## QUALITY ASSURANCE -- NON-CONFORMANCE REPORT

**Report No:** NCR-000568

<b>Welding</b>	<b>Concrete</b>	<b>Other</b>	
<b>Welding</b>	<b>Curing</b>	<b>Procedural</b>	<b>Bridge No:</b> 34-0006
<b>Joint fit-up</b>	<b>Coating</b>	<b>Other</b>	<b>Component:</b> OBG Segment 7EW Side Plate
<b>Procedural</b>	<b>Procedural</b>	<b>Description:</b>

<b>To:</b>	AMERICAN BRIDGE/FLUOR, A JV 375 BURMA ROAD OAKLAND CA 95607	<b>Date:</b>	29-Dec-2009
<b>Dear:</b>	Mr. Charles Kanapicki	<b>Contract No:</b>	04-0120F4 04-SF-80-13.2 / 13.9
<b>Attention:</b>	Mr. Thomas Nilsson Project/Fabrication Manager	<b>Job Name:</b>	SAS Superstructure
<b>Subject:</b>	NCR No. ZPMC-0541	<b>Document No:</b>	05.03.06-000531

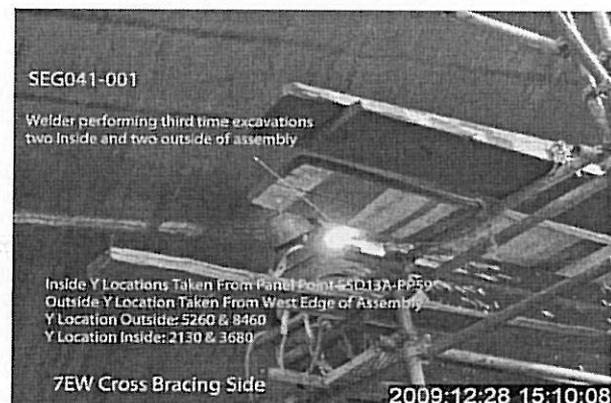
This QA observed ZPMC welding personnel performing third (3rd) time weld repair excavations to Seismic Performance Critical Material (SPCM) weld without the Engineer's approval or an Critical Weld Report (CWR) in the following four (4) locations:

-“Y” = 5260mm and 8460mm on the outside surface pulling from the west end of the segment.

-“Y” = 2130mm and 3680mm on the inside surface pulling from Panel Point 059.

-The Orthotropic Box Girder (OBG) segment is identified as 7EW.

-The weld is identified as SEG041A-001.

-The weld is designated as SPCM on the approved drawings.

-The weld is a Complete Joint Penetration (CJP) butt joint joining Side Panel identified as SP433A (SPCM) to SP101A.

Caltrans Special Provisions section 8-3.01 specifies In addition to the provisions in AWS D1.5, section 3.7.4 and section 12.17, third time repairs of welds, or base metal, regardless of NDT method,...require prior approval of the Engineer.”

**Reference Resolution:** Excavation by ZPMC is allowed without a CWR/WRR in order to determine the extent of the underlying indication and to determine if the indication has been fully removed before weld repair begins.

The incident documented by the inspector for this NCR is excavation. Excavation by ZPMC is allowed without a CWR/WRR in order to determine the extent of the underlying indication and to determine if the indication has been fully removed before weld repair begins. In this case, only the excavation was performed. As previously agreed to by the Department this activity alone does not constitute a non conformance. Based on this, ZPMC requests that this NCR be closed.

This proposed resolution is acceptable. The Department concurs that Non-Conformance ZPMC-0541 is closed.
